PASCO COUNTY, FLORIDA  
INTEROFFICE MEMORANDUM

FROM: Debra M. Zampetti                                      SUBJECT: Class III, Subdivision Development Review - Talavera Subdivision Variance Request (Project No. SDU05-060)  
Zoning/Code Compliance Administrator                                      DRC: 12/22/11, 1:30 p.m., NPR  
Recommendation: Approval with Conditions

**TALAVERA PROJECT  
25' CATEGORY I WETLAND SETBACK VARIANCE REQUEST**

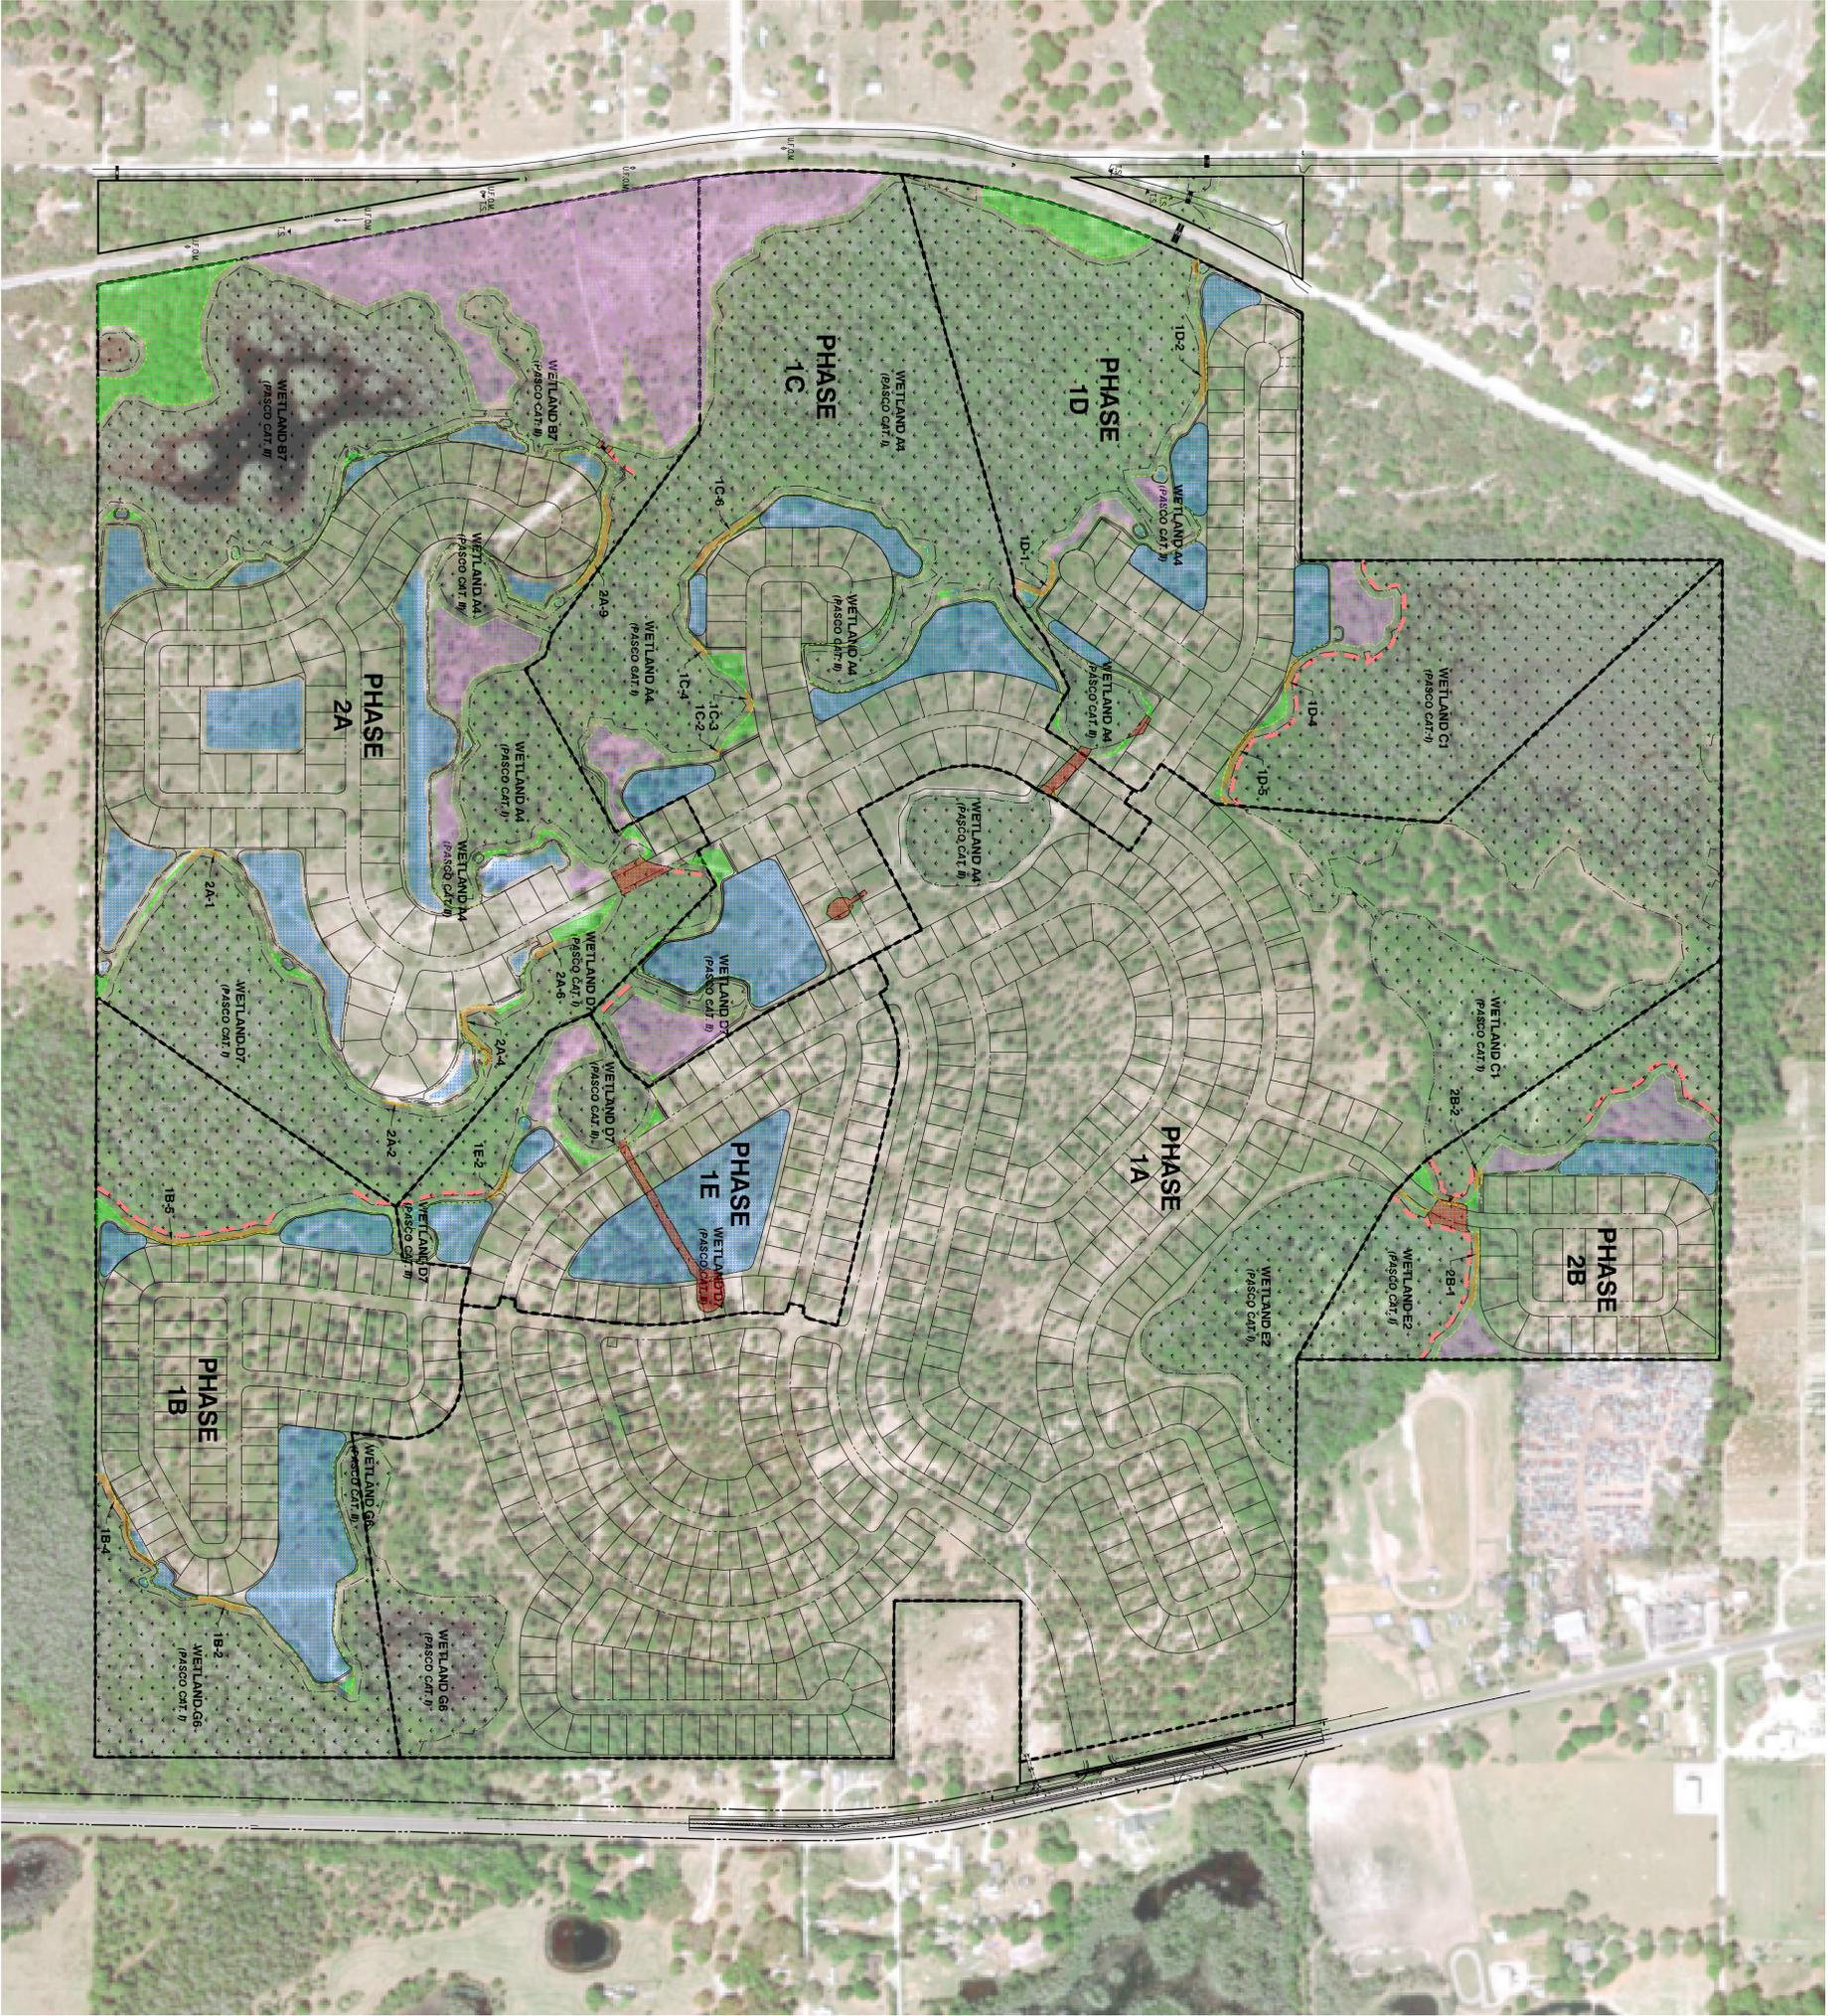
3. The applicant/developer may utilize the approved Phase 1A rim-ditch areas as identified as orange-dashed lines on the "wetland setback buffer exhibit map" dated October 12, 2011, for proposed infrastructure with an average setback of 10 feet as per the SWFWMD recommendation, which encroaches on an average of 15 feet into the wetland setback.

5. For Category I wetlands in Phases 1B through 2B, the reduced upland wetland buffer along both the rim-ditched and non-rim-ditched wetlands are to be in accordance with the approved SWFWMD plans and are to consist of an average 15-foot setback encroachment per Attachment B.

6. The applicant/developer shall add additional upland buffer acreage to the project site as depicted on Attachment B. These areas shall remain in a natural state, and shall be depicted on the construction plans as Upland Buffer Expansion Areas. The Upland Buffer Expansion Areas shall be platted as tracts.

**Exhibit D**  
**Upland Buffer/Setback Aerial Exhibit**

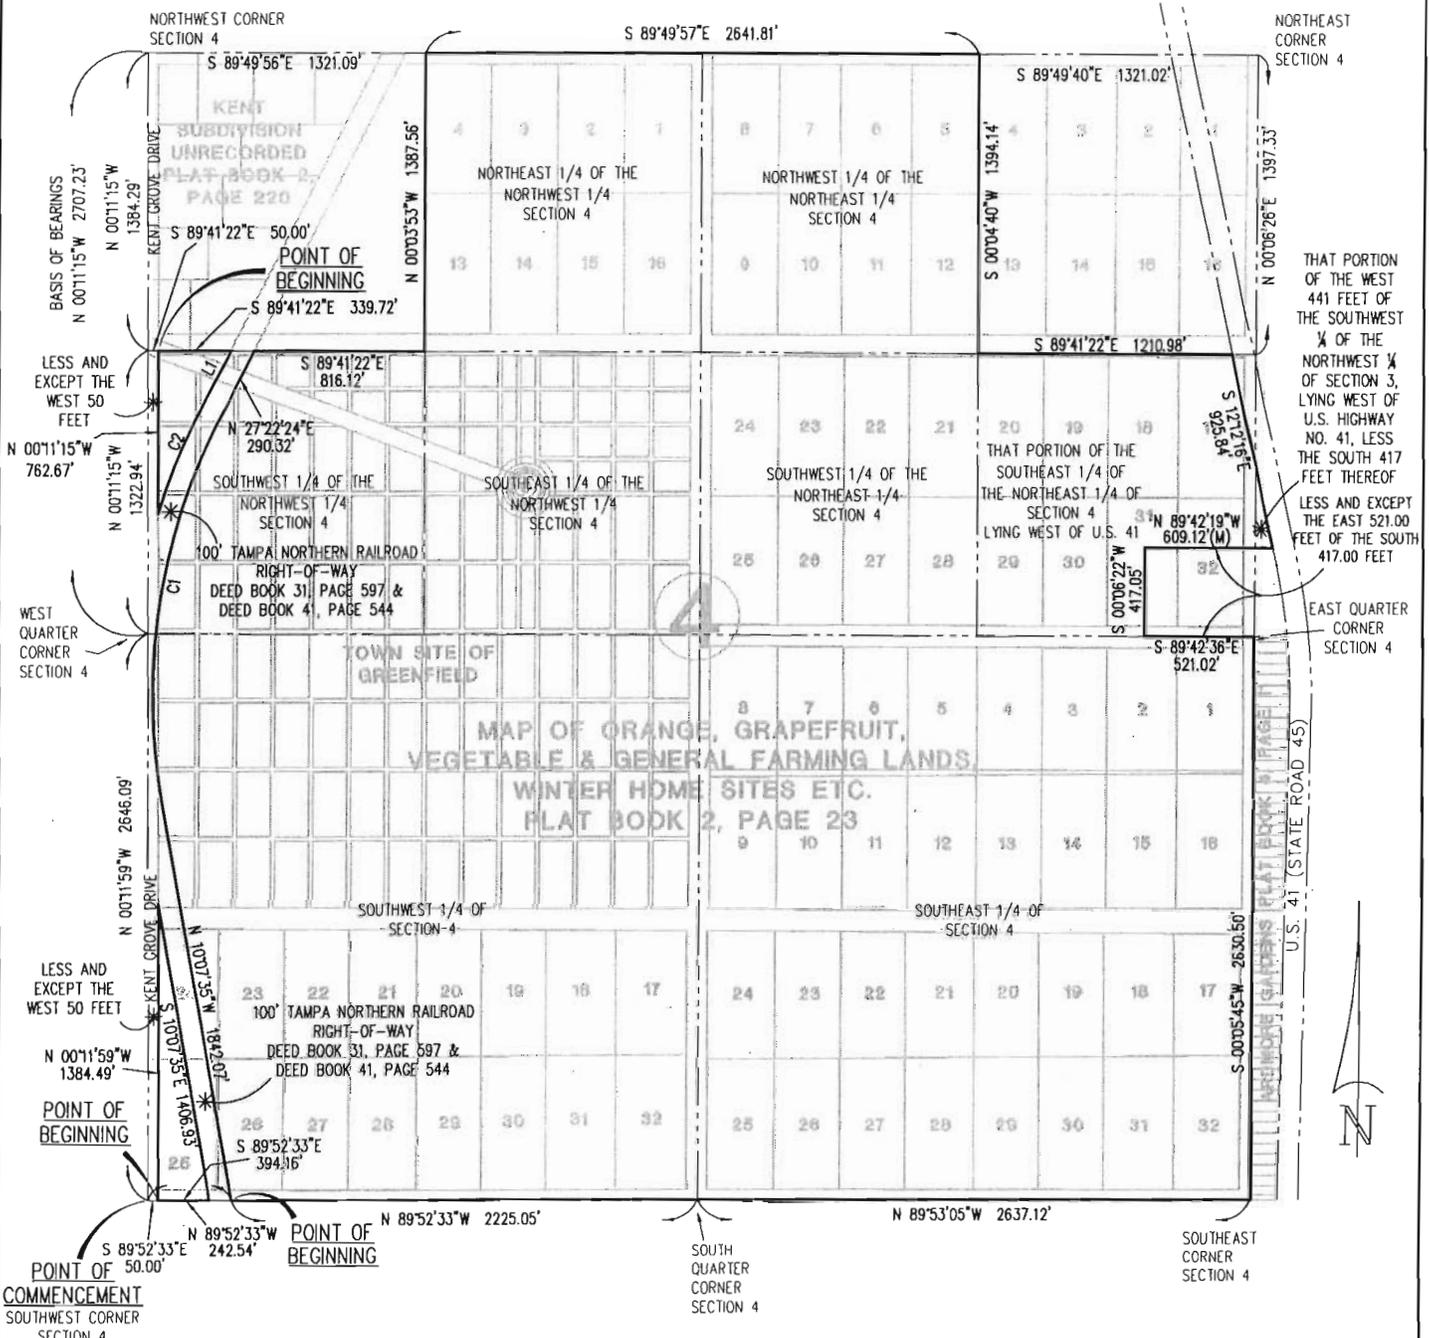
The attached Wetland Setback/Buffer Exhibit (**Exhibit D**), depicts the basic, overall site plan layout (lots, roads and ponds), along with color coded shading for stormwater ponds, floodplain compensation areas, wetland mitigation areas, wetland impacts, upland setback encroachment areas, upland setback expansion areas and rim ditches (as field-verified by King ecologists).

It is understood that there are existing provisions in the County LDC that do allow (without need for a variance) for certain activities/features within the 25-foot setback of a Category I wetland. These allowable activities include wetland mitigation and floodplain compensation (where such features would enhance the function of the wetland), as well as spreader swales and stormwater discharge structures. Placement of stormwater ponds is "discouraged" in the LDC, but not expressly prohibited. So, the limitation (need for variance) is specific to features such as lot pads, roads and other fill or hardscape features. Based on review of the current Talavera site plan, a number of implied encroachments into Category I setback areas have been identified. These areas (shaded orange on the attached graphic) can be cross-referenced to the rim-ditch areas (bold pink dashed line) to focus the variance review areas.
